UNITED STATES PATENT AND TRADEMARK OFFICE

APPLICATION NO.	FILING DATE	FIRST NAMED INVENTOR	ATTORNEY DOCKET NO.	CONFIRMATION NO.
10/537,212	04/03/2006	Karlheinz Freywald	D4695-00134	1864

Office Action Summary	Application No.	Applicant(s)	
	10/537,212	FREYWALD, KARLHEINZ	
	Examiner	Art Unit	
	REEMA PATEL	2812

DETAILED ACTION

FIG. 4A.

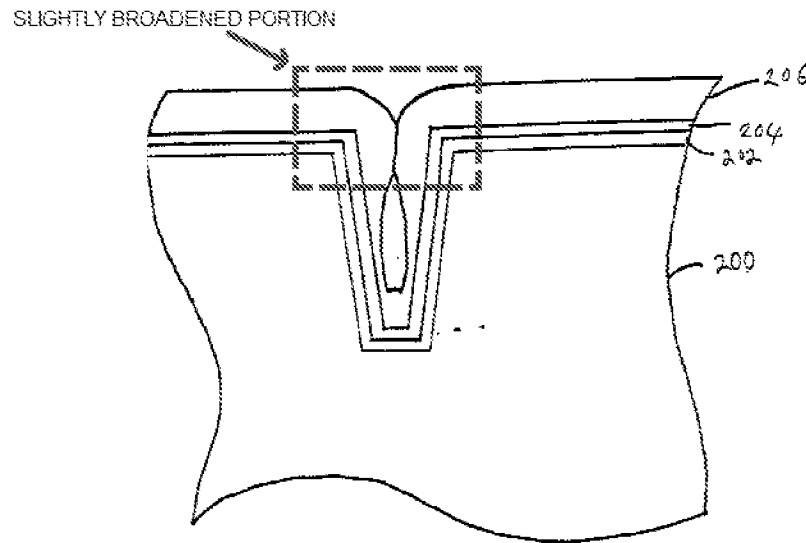
10. Regarding claims 1, 4-5 and 12-13, Campana discloses a method for sealing an isolation trench, wherein the trenches are slightly broadened at specific positions (see examiner-marked Fig. 4a below) and a low pressure deposition technique is used such that void channels are formed in the area of the trenches having normal width by closing the upper trench portions with a fill material are hermetically sealed in the longitudinal direction of the trench by means of low pressure material deposition from the broadened trench portion along the length direction of the trench ([0033]-[0034]; Fig. 4a).

11. Regarding claim 9, Campana discloses the broadening occurs near the upper edge of trench (Fig. 4A) and is conical in shape.
12. Regarding claim 10, Campana discloses the low pressure technique is performed at near vacuum conditions ([0034]).
13. Regarding claim 11, Campana discloses the broadening is short compared to the total length of the channel (Fig. 4a).
14. Claims 1, 3, 5, and 7 are rejected under 35 U.S.C. 102(b) as being anticipated by Nitta et al. (U.S. 2002/0040994 A1; 'Nitta').
15. Regarding claims 1 and 5, Nitta discloses a method for sealing an isolation trench, wherein the trenches (2, Fig. 3) are slightly broadened at specific positions (Fig. 3) and a low pressure deposition technique is used such that void channels (2a, Fig. 4) are formed in the area of the trenches having normal width by closing the upper trench
